PLANNING COMMITTEE ADDENDUM

2.00PM, WEDNESDAY, 2 DECEMBER 2020

2nd December 2020 Planning Committee – Additional Representations

Planning Committee 2 December 2020 – Member Questions

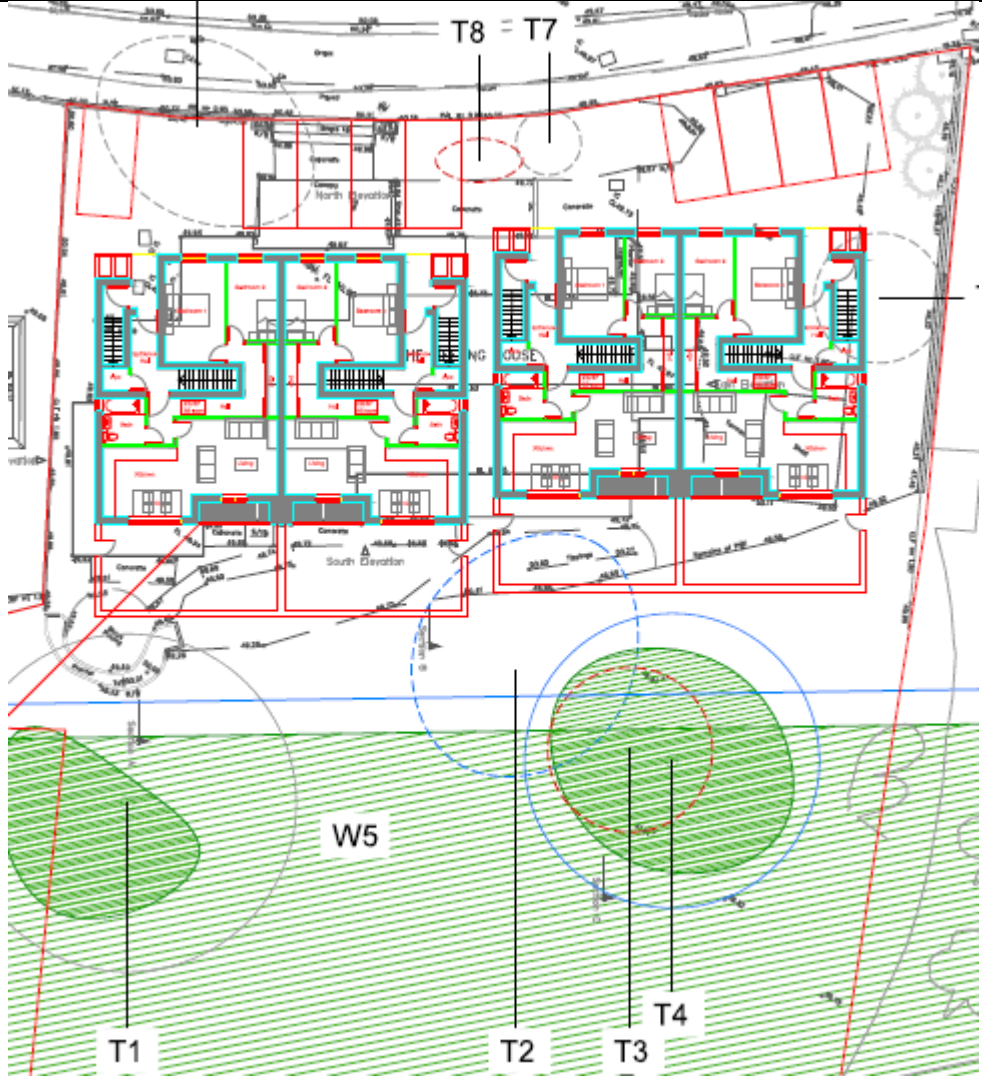
footway now extends for a greater distance along the southern side of the road before pedestrians are required to cross to the north side, which will benefit existing properties. From the junction with the road leading to the Kennels onwards, the alignment and layout differs.
Item B: BH2020/01742 The Meeting House, Park Close		
1	Can the T2 Ash tree at the rear be saved?	Please see plan below showing Tree T2 in very close proximity to the proposed development:

<p>The submitted Arboriculture Report states the following:</p> <p><i>“Rooting area conflicts with the new rear courtyard area and building foundations. Based on the likely loss of roots associated with excavations required for the building foundations and the site’s topography making use of an above ground hard surface difficult, T2 is not considered feasible to retain. A new specimen tree should be planted in a similar location to mitigate the loss of the T2.”</i></p> <p>The Council’s Arboriculture Officer has confirmed the following:</p> <p><i>“T2 is certainly plotted in close proximity to the proposed structure. It would be unlikely to survive post development due to root removal, canopy overhang and soil compaction. It looks near impossible to maintain an exclusion zone; they would certainly need to redesign foundations and surface levels.</i></p> <p><i>Realistically with Ash dieback becoming prevalent, the tree is likely to require removal within the next 5 years on safety grounds, irrespective of development. I wouldn’t consider specifying retention as reasonable, and significant mitigative planting is the better option.”</i></p>
